Australian  
Institute of  
Architects

**Re: Response to Mid-Rise Standards Consultation Draft**

#### **Side and rear setbacks objective**

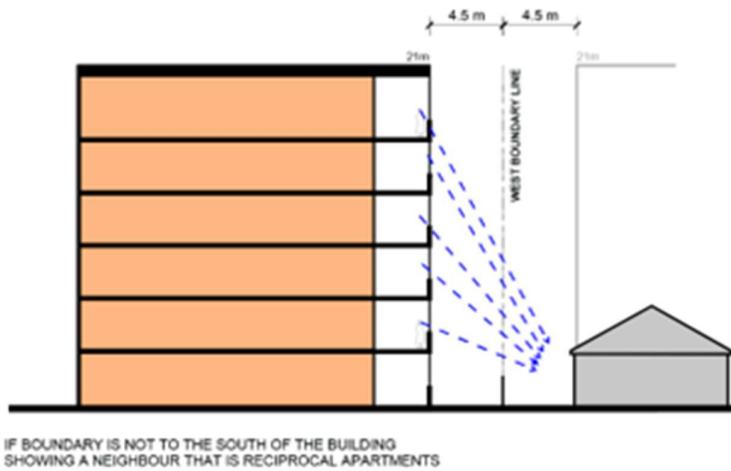
We note that the diagrams included in the consultation draft typically show a 'reciprocal' apartment development' to the adjacent property. It is important to consider how the code will operate over time, however we believe it is important to also show the likely scenario at the beginning of the code's use, where adjacent properties will typically be one or two storey dwellings, given the proposed broad application of the standards across residential and mixed-use zones. The diagram below is an adaptation of that included to illustrate the side and rear setback objective amended to show a detached dwelling on the adjacent property.

Potential semi and elevated parking structure resulting from walls on boundary objective options A and B.

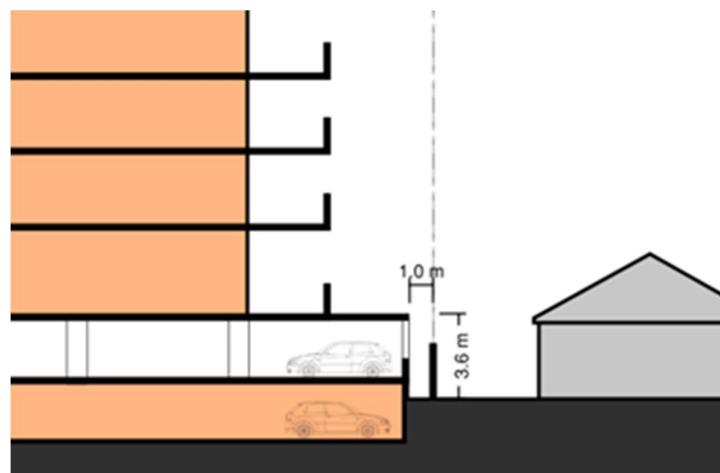
As drafted, the increased 3.6m height allowance for a boundary wall outlined under Option A and B may encourage proponents to build shallow-semi-basements and then a second level of car parking above ground to avoid excavation costs associated with full basements.

The standard potentially allows for above ground car parking level within 1m of the side boundary, which is likely to result in a poor amenity outcome for adjacent properties. The 1m setback to side boundary does not provide sufficient soil depth and volume to allow for planting or screening to provide a buffer to a car park. Refer diagram below for illustration of potential outcomes.

We note there is a requirement to visually conceal cars from a street under the Street Integration objective, but the balance of the ground level and level 1 can be carparking, and there is no requirement to screen cars on elevated parking structures from side boundaries.

We recommend refining this standard to allow for increased walls on boundaries, restricting above ground parking and parking structures and requiring adequate separation for landscape screening to side and rear boundaries and or to require cars to be visually screened from side or rear boundaries.

Building separation within a site objective – Option B highlighting lower apartments do not receive daylight between equinox dates.

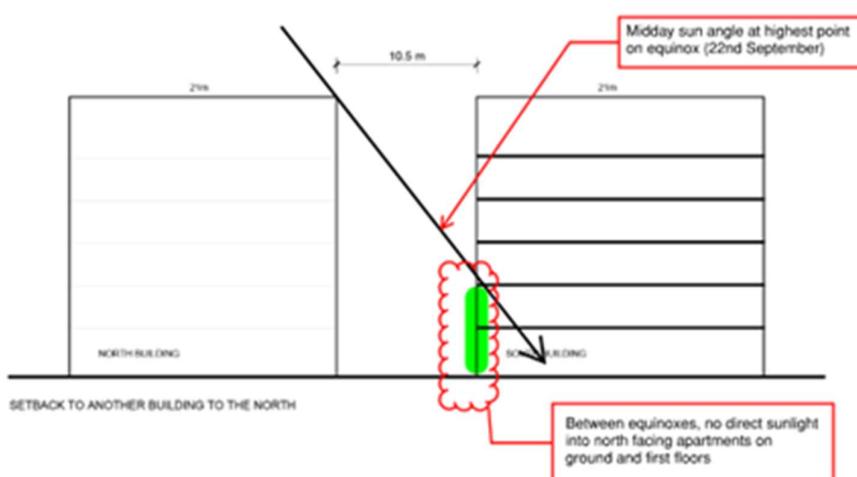
We recommend adopting Option B as a minimum starting position. Option A allows for a minimum 10.5m separation to north facing elevations which results in ground and first floor facing apartments receiving no direct sunlight for six months of the year between March 22 and September 22 each year. Option B, which allows for sunlight to reach ground floor apartments on the equinox, is preferred.

#### Overlooking objective

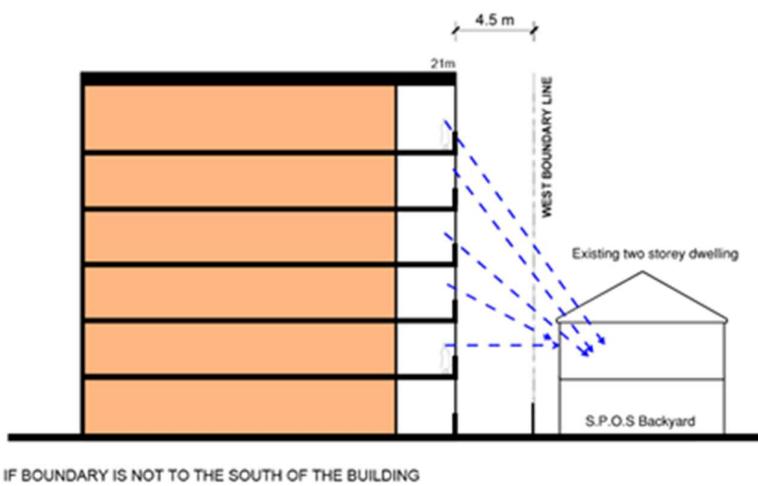
Similar to the operation of the overshadowing objective, the overlooking standard outlined for Option A applies only when side and rear setbacks are not met.

Both options remove bedroom windows from having to meet overlooking requirements as they are redefined as not being habitable rooms under this standard. While the Institute is not in favour of poorly considered and designed overlooking prevention screens being attached to habitable room windows, we also do not believe that removing bedroom windows from consideration of overlooking is appropriate or logical. As written, we would expect to see scenarios where an upper-level living room window immediately adjacent to a bedroom window, both facing the same direction, would require an overlooking prevention screen to the living room and not the bedroom.

While Option B operates when side and rear setbacks are met, it undermines the operation of any overlooking requirement by lowering the height of any required overlooking prevention device from 1.7m to a height of 1.5m above finished floor level. This height is inadequate given the average height of Australian men and women<sup>2</sup> exceeds the overlooking screen height.

The image below shows the likely real-world operation of both options A and B where a new building is built within the side and rear setbacks and will either have no (Option A) or inadequate (Option B) overlooking prevention devices to an adjacent secluded private open space or habitable room windows. On balance, we do not believe this is a reasonable or fair outcome for existing residents when there are no appeal rights under the revised clause.
